Mobile Intel[®] Pentium[®] II Processor Specification Update

Release Date: April 2002

Order Number: 243887-039

The Mobile Pentium[®] II processor may contain design defects or errors known as errata which may cause the product to deviate from published specifications. Current characterized errata are documented in this Specification Update.

Old Mobile Pentium® II Processor in Mini-Cartridge Package Label with Supplier Matrix Mark

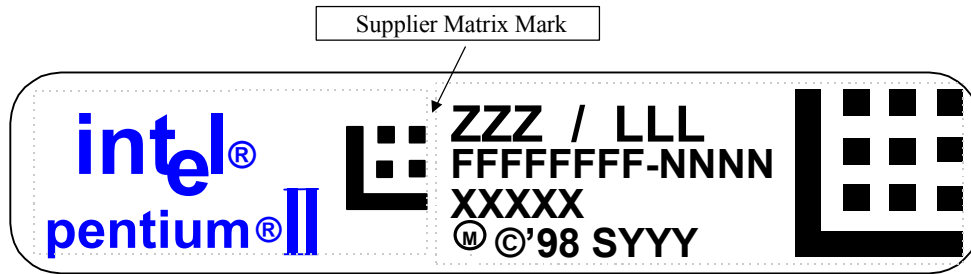
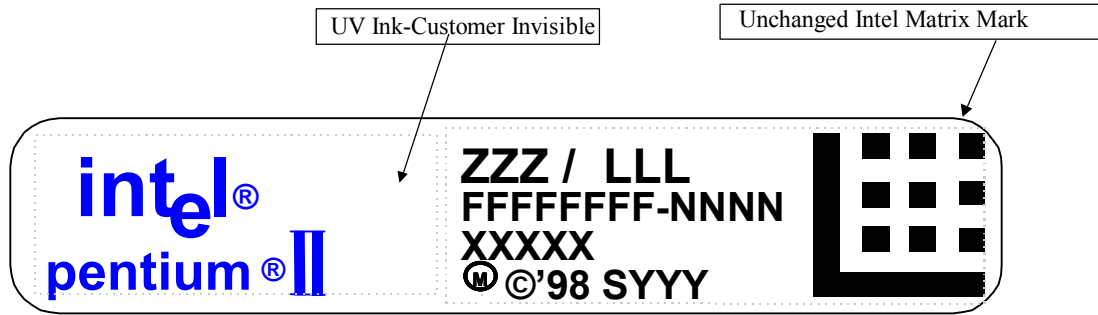
New Mobile Pentium® II Processor in Mini-Cartridge Package Label with Supplier Matrix Mark Removed

Figure 2. Workaround Flowchart: SMBALERT#-Driven System

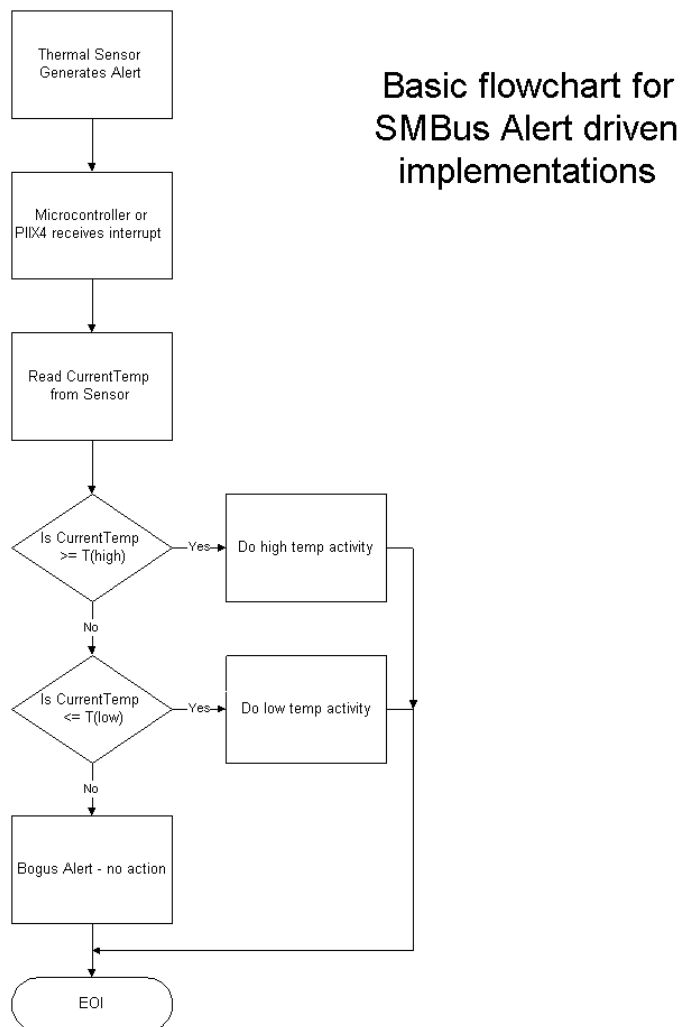
1. Before servicing an interrupt from the thermal sensor, read and compare the processor thermal reading with the threshold limits (T_{HIGH} or T_{LOW}). Figures 2 and 3 provide basic flowcharts for the implementation of this workaround in an interrupt driven system.
2. If the firmware implemented polls the Status Register only, then before taking any action, re-read the temperature register and do a comparison with the alarm threshold limits (T_{HIGH} or T_{LOW}) to determine if the value is actually still within the temperature window.

3. Use a temperature polling scheme to monitor the processor temperature.

Figure 1. TAP Gageable Thread Clarification

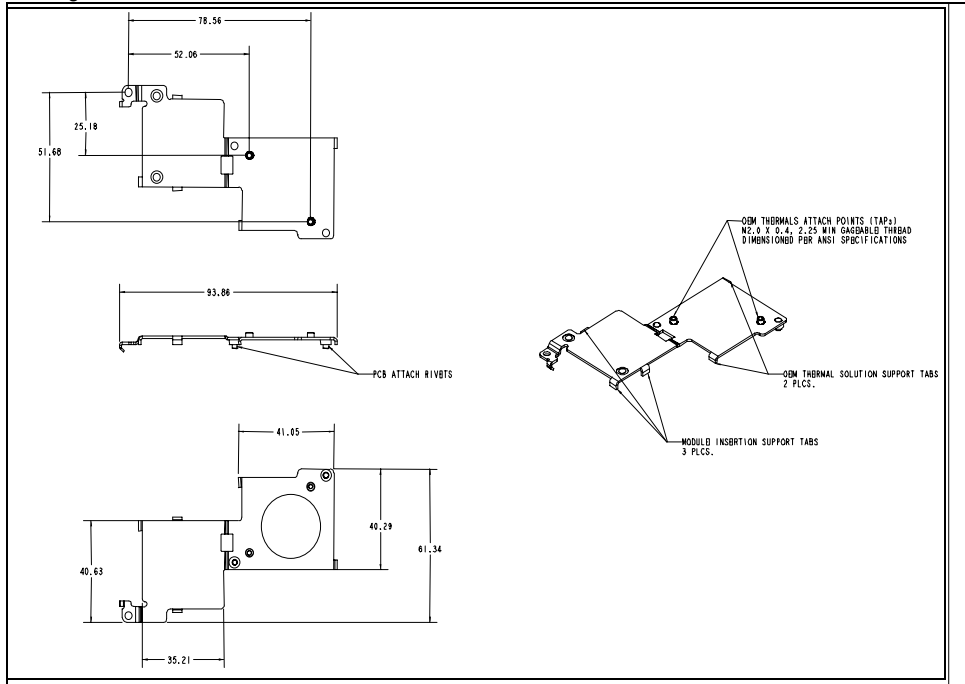
In the *Intel® Pentium® II Processor Mobile Module : Mobile Module Connector 1 (MMC-1)* and the *Intel® Pentium® II Processor Mobile Module : Mobile Module Connector 2 (MMC-2)* datasheets (Order Numbers 243667 and 243668, respectively), the thermal attach point (TAP) gageable thread specification was not clearly identified in Figure 14, of Section 5.2. The following is the TAP clarification:

OEM Thermal Attach Points (TAPs) M2.0 x 0.4, 2.25 min gageable thread dimensioned per ANSI specification.

See Figure 1 below for more information.
